Project: Ability Inclusion Services

Addendum #3

1 Questions on AIS - Architect Response

Ability Inclusion Services - Questions

A-101 3/19/2025

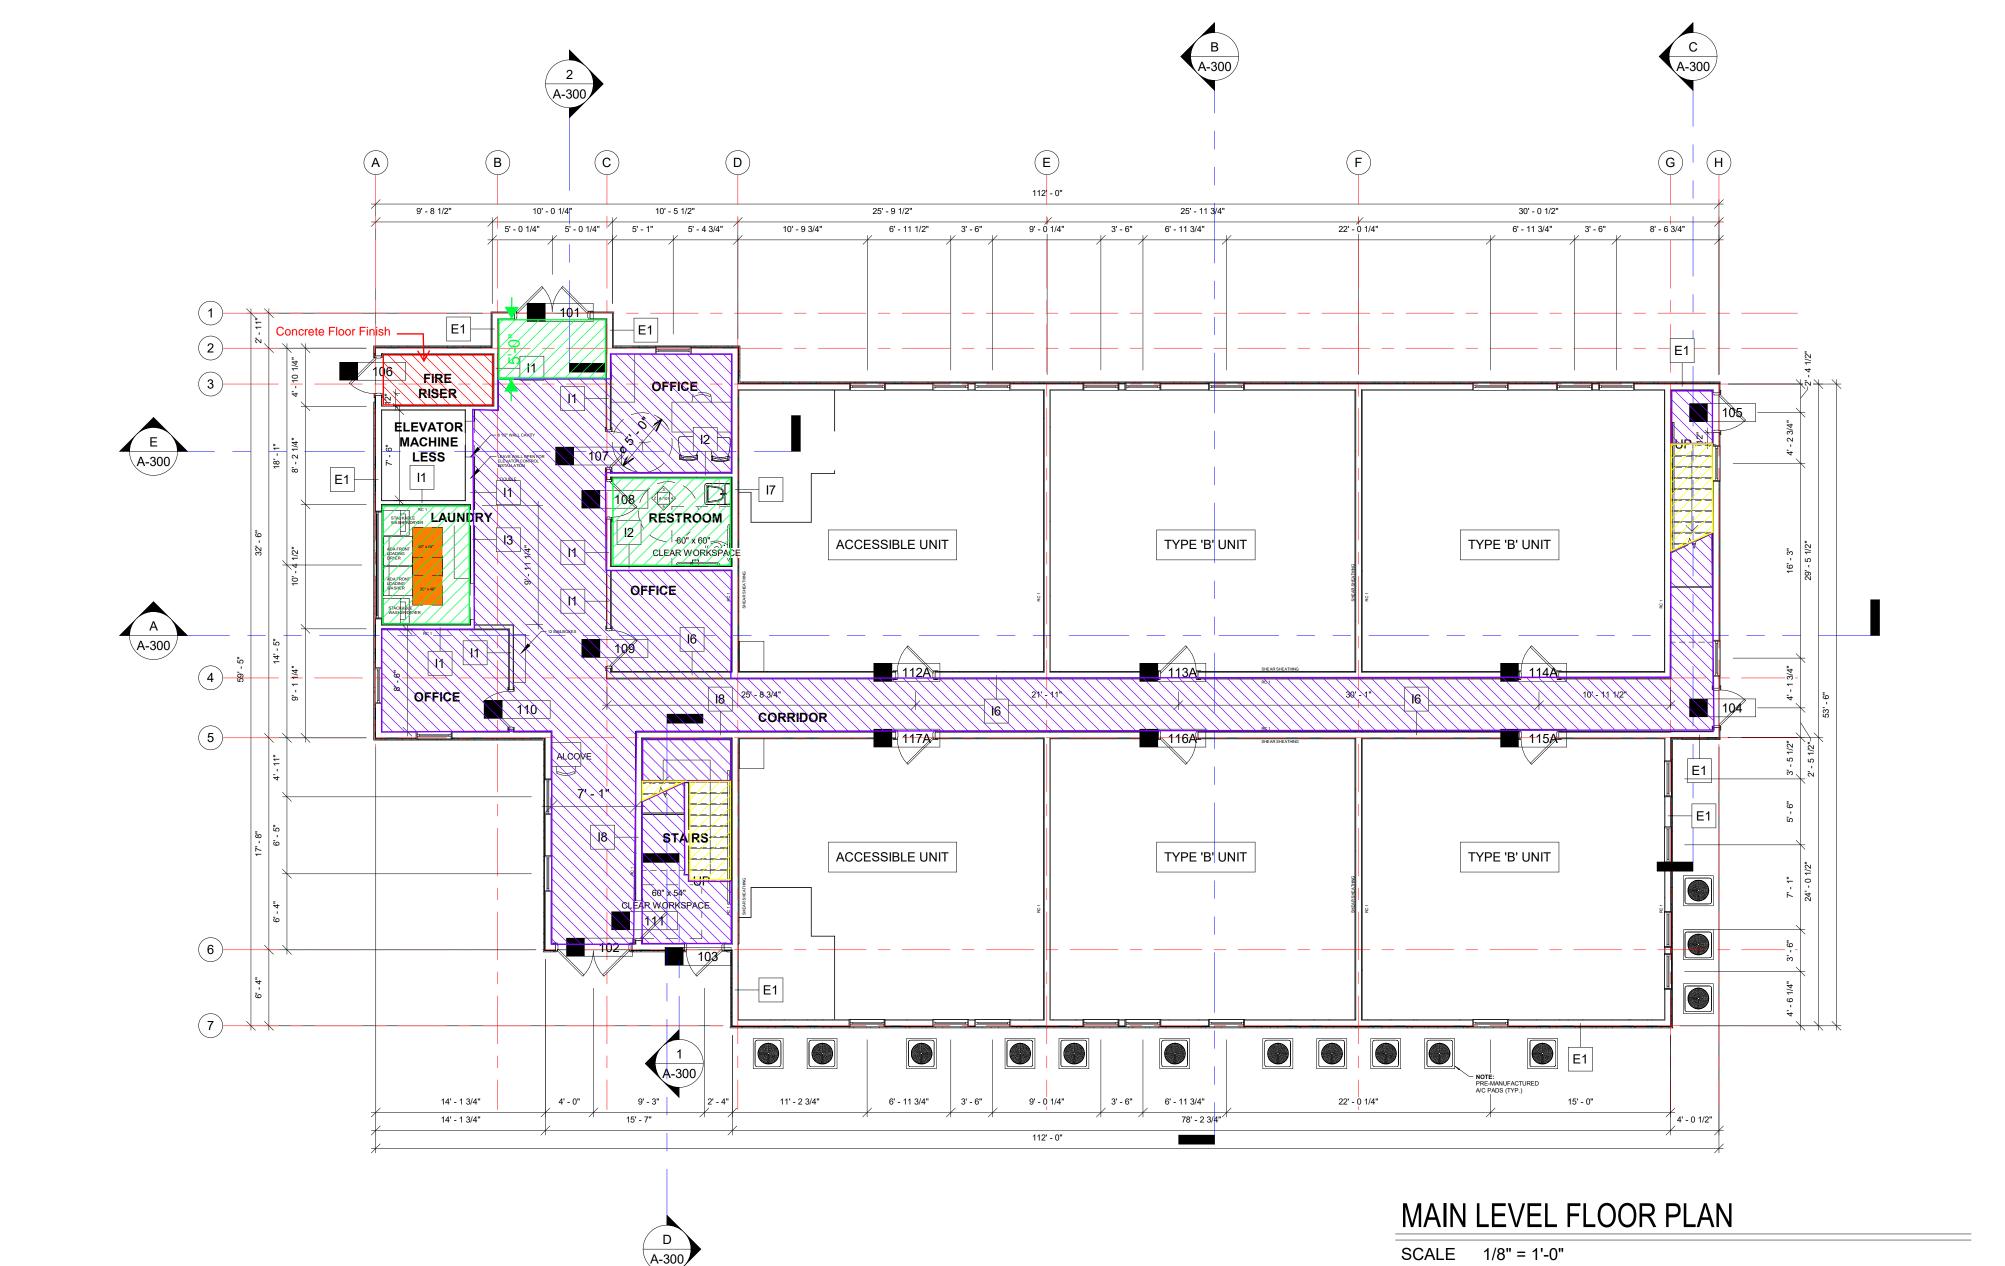
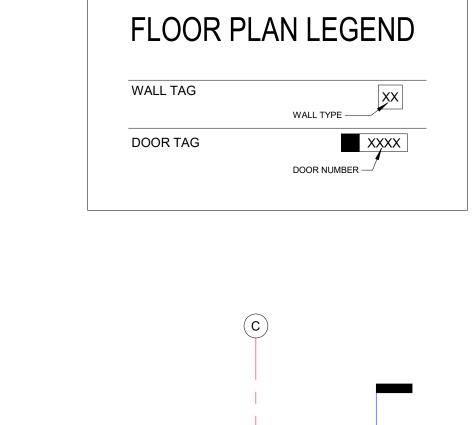
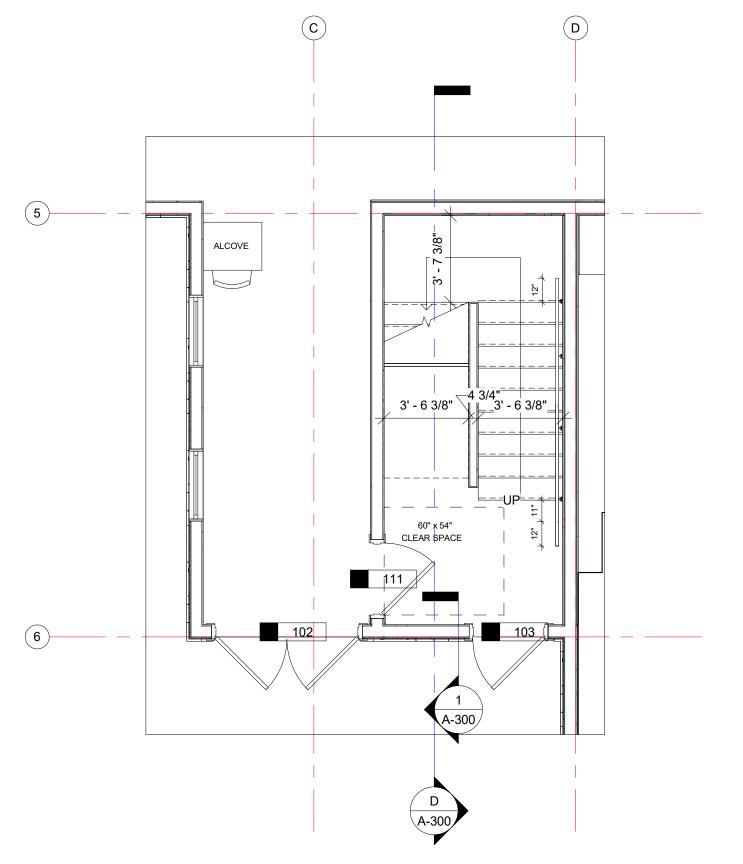
- Floor types are not called out. Please provide a material/finish schedule for tile, lvt, carpet, etc. with locations.
 Material selections given in design guideline. For clarification colored floor and unit plans; LVT purple, Tile green, Rubber Stair Tread yellow, Fire Riser Room Concrete red

A-400 3/19/2025

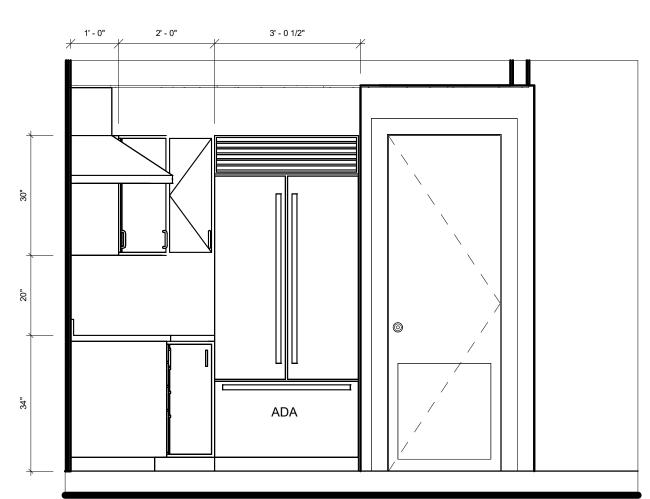
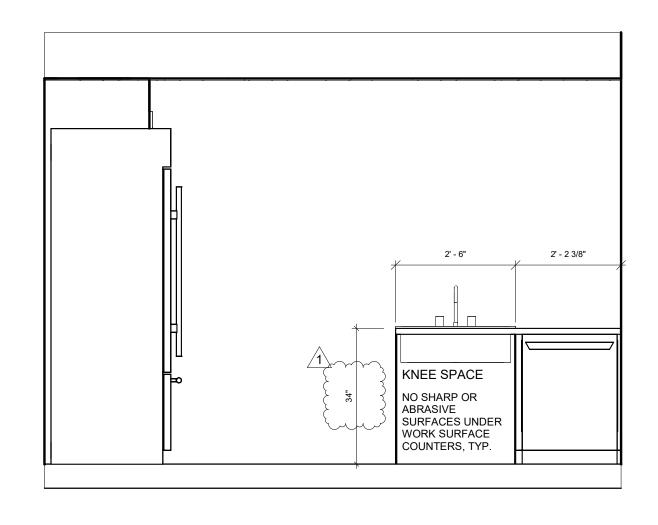
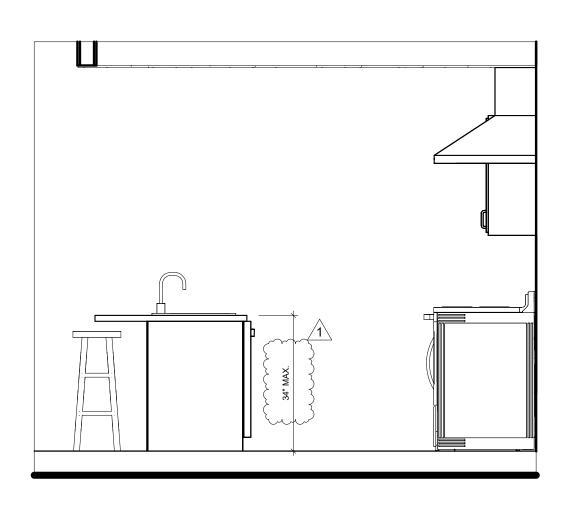
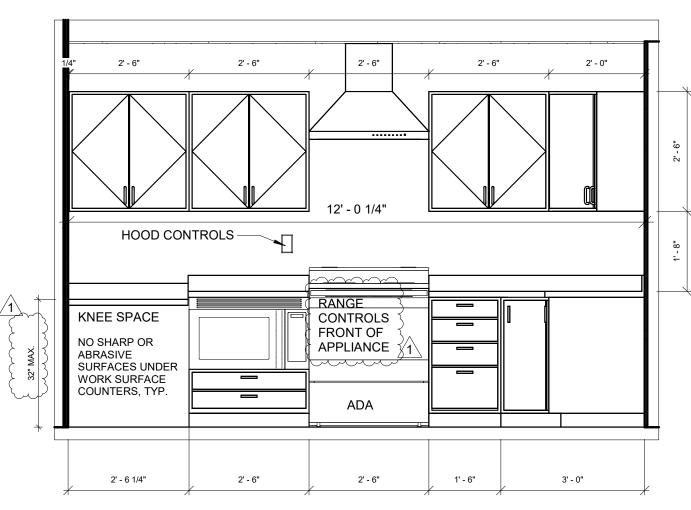
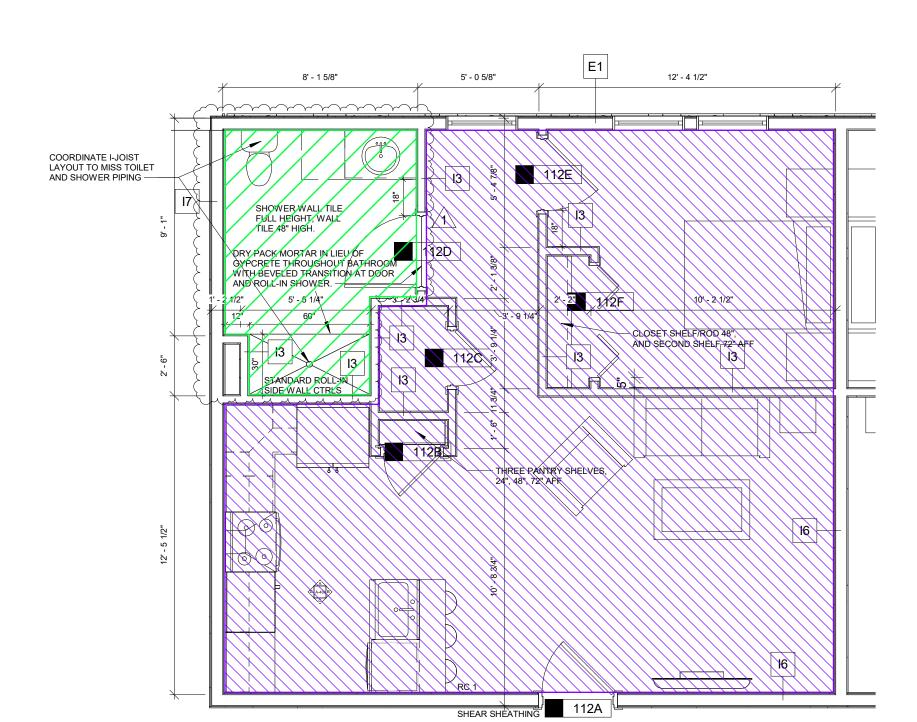
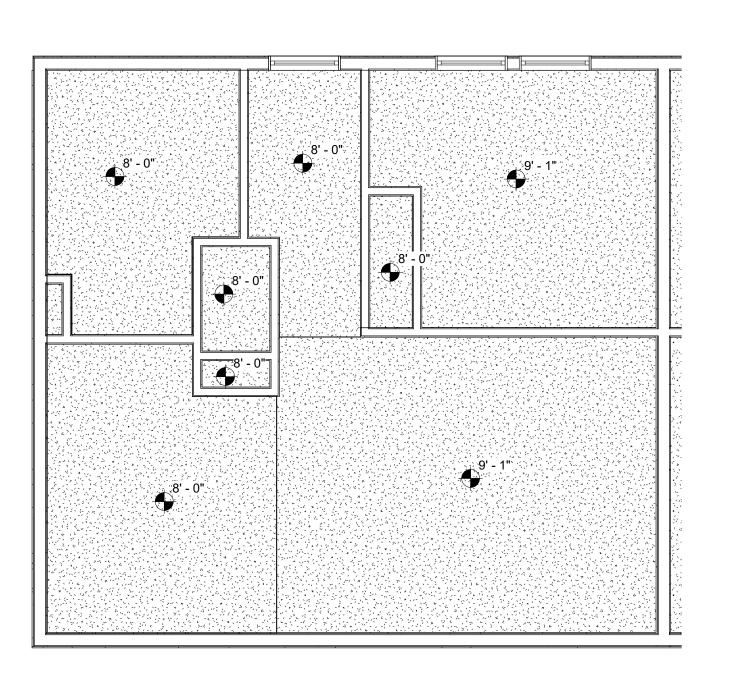
- The specifications, 064023 show both wood veneer and plastic laminate cabinets and laminate and Quartz counter tops. There is a material callout on page A400. Please provide a finish schedule for the cabinets and counter tops. All countertops Arizona Tile Delta Terra Quartz. Cabinets wood oak veneer.
